Access Compliance Report

Public Rights-of-Way

Intersection ID: N/A	Main Street: LAKESIDE_DR	Cross Street: KRISTEN_LAKE_CT	Location: NW
ADA ID: 2BE1C8E5F677	Ramp Type: PerpDiag	Initial Pass/Fail: Fail	Overall Compliance: No
		Severity Score: 50

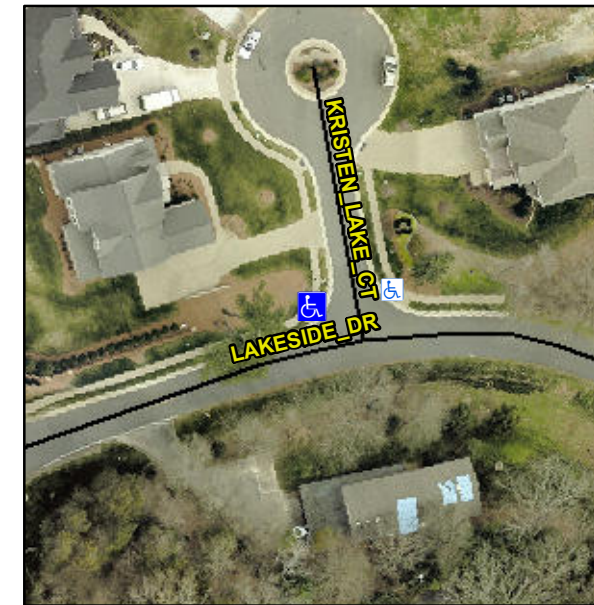
Not Found, R304.2.2, R304.5.3

Compliance	Description	Data	Compliance	Description	Data
N/A	Ramp Length (in)	49.0	No	Ramp Slope (%)	16.0
Yes	Ramp Width (in)	48.0	No	Ramp XSlope (%)	8.9
N/A	Flare Type LT	N/A	N/A	Flare Type RT	N/A
N/A	Flare Slope LT (%)	N/A	N/A	Flare Slope RT (%)	N/A
N/A	Flare Traversable LT?	N/A	N/A	Flare Traversable RT?	N/A
N/A	Landing Length (in)	N/A	N/A	DWS Provided?	N/A
N/A	Landing Width (in)	N/A	N/A	DWS Contrast?	N/A
N/A	Landing Slope (%)	N/A	N/A	DWS Length (in)	N/A
N/A	Landing X Slope (%)	N/A	N/A	DWS Full Width?	N/A
N/A	Landing Curb? (Y/N)	N/A	N/A	DWS Offset (in)	N/A
N/A	Shared Landing?	N/A			
N/A	Gutter Ponding?	N/A	N/A	Gutter Slope (%)	N/A
N/A	Gutter Lip Ht (in)	N/A	N/A	Gutter X Slope (%)	N/A
N/A	Painted X Walk1?	No	N/A	Painted X Walk2?	No
	X Walk 1 Direction	To S		X Walk 2 Direction	To E
N/A	X Walk 1 Width (in)	N/A	N/A	X Walk 2 Width (in)	N/A
	X Walk 1 Slope (%)	6.8		X Walk 2 Slope (%)	3.5
	X Walk 1 X Slope (%)	3.6		X Walk 2 X Slope (%)	6.0

Remove & Replace Curb Ramp With Two New Directional Ramps or Equivalent.
